County of Amherst

Department of Planning & Zoning

RE: September 26, 2017 DRC Meeting – Boat Barn at VA Canals and Navigations Society; 3806 S. Amherst Highway;
Tax Map Parcel # 147C-8-A-42-53

The following comments need to be addressed regarding planning and zoning:

AERIAL of SOUTH ELEVATION

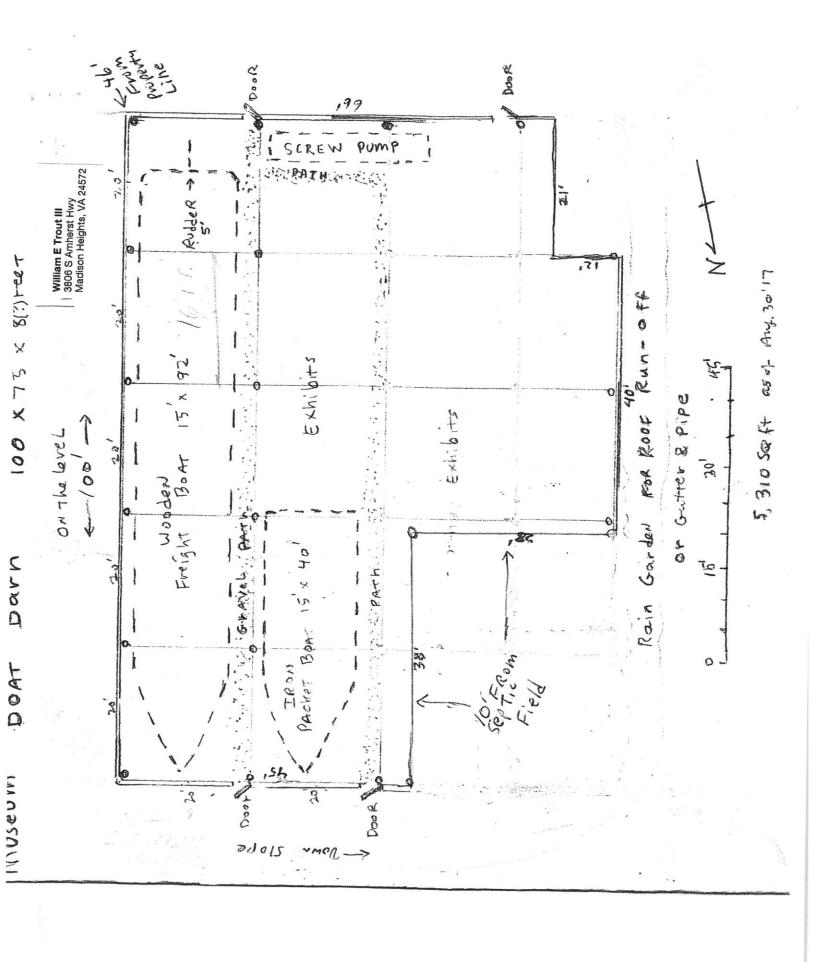
- 5. Site parking is to be located a minimum of 35 feet (50 feet preferred) from the

closed edge of travel lane of Route 29 Business.

16600gle Earth 3806 S. April 2014 Amherst Hwy, Madison Heights VA 24572 730 Proposed boat barn Ł 9 Highview Dr 678 29 Bus S Amherst Hwy 0 400 ft William E Trout III 3806 S Amherst Hwy Madison Heights, VA 24572 1 100

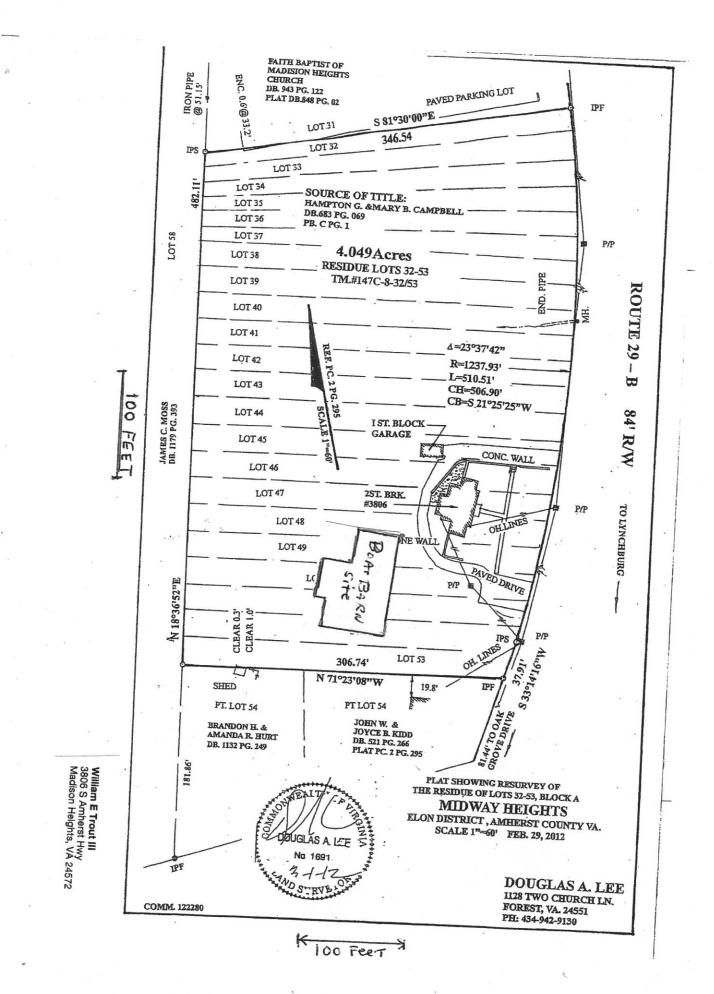
- 1. Per Section 1104.02.4.a, please correct the following adjoining property owner information:
 - Add address for adjoining owner James C. Moss (152 Oak Grove Road)

- Correct house number for adjoining owner Brandon H. Hurt (138 Oak Grove Road)
 - Include all adjoining property owner names. "Brandon H. Hurt and Amanda R. Stewart" and "John W. and Joyce B. Kidd"

- 2. Per Section 1104.02.4.b, please include zoning of adjoining owners and of subject property.
- 3. Per Section 1104.02.5.a, please include signature blocks for the zoning administrator, Virginia Department of Transportation, and Health Department.

- 4. Per Section 1104.02.5.d, indicate both existing and proposed parking areas. Floor area of existing Batteau House will be needed for this calculation.

- 5. Per Sections 1104.02.5.f, 1607.a, and 1607.b.1, show existing vegetation to satisfy 20 foot screening strip requirement where property is adjacent to a residential district.

- 6. Per Section 602.02.2, identify if any outdoor lighting will be used on the site.
